Ref: P4528/L02a/AGB

Elizabeth Street, Cheetham Hill – Additional Addendum to Noise Impact Assessment.

- 1.1 This letter forms an additional addendum to the noise impact assessment report (P4528-R1b-AGB) that was previously issued 20 April 2022 in relation to the application for the construction of 9 light industrial / commercial / warehouse units on a site off Elizabeth St, Cheetham Hill, Manchester. The proposals are for 24-hour operation of the units over seven days per week.
- 1.2 After submission of AEC's report an addendum was prepared (AEC ref. P4528/L01a/AGB) and issued by AEC on 29 June 2022, which responded to points raised in Manchester City Council's (MCC) Draft Planning Conditions 14 to 17 which were associated with noise.
- 1.3 Planning permission was granted and Kier has requested that AEC respond to planning conditions 15 and 16, which are detailed below.
- 1.4 Planning condition 15 states:

Figure 2 – Key Features of the 12K Envirofence

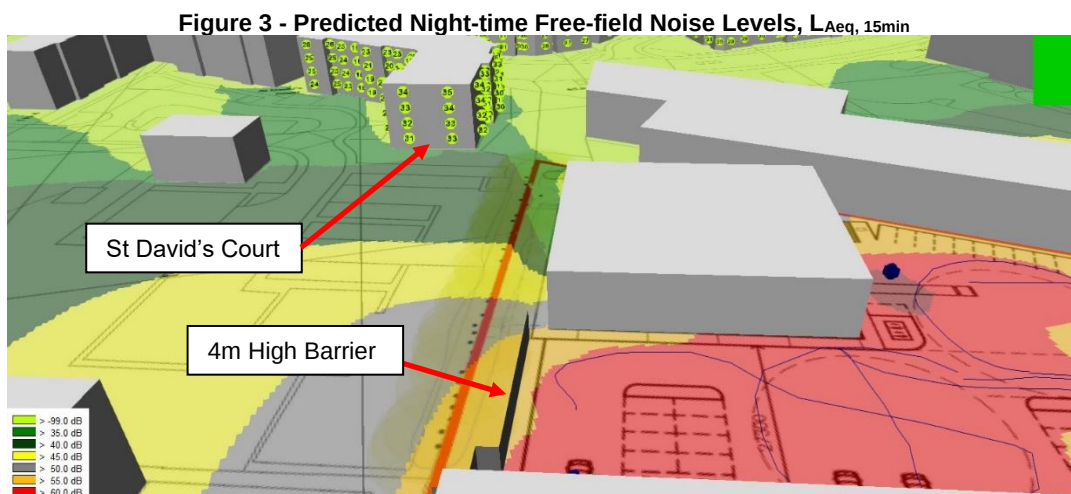
- 2.3 With reference to the Jackson's Fencing brochure, Figure 2, below, presents the key features for the 12K Envirofence.

- 2.4 As can be seen above, the fence meets the surface weight requirements of at least 10kg/m² which has been calculated using the footnote on page 14 of The Department of Transport's 'Calculation of Road Traffic Noise' 1988 (CRTN) which states that the superficial mass requirements for a barrier can be calculated using (where A is the required reduction in dB):
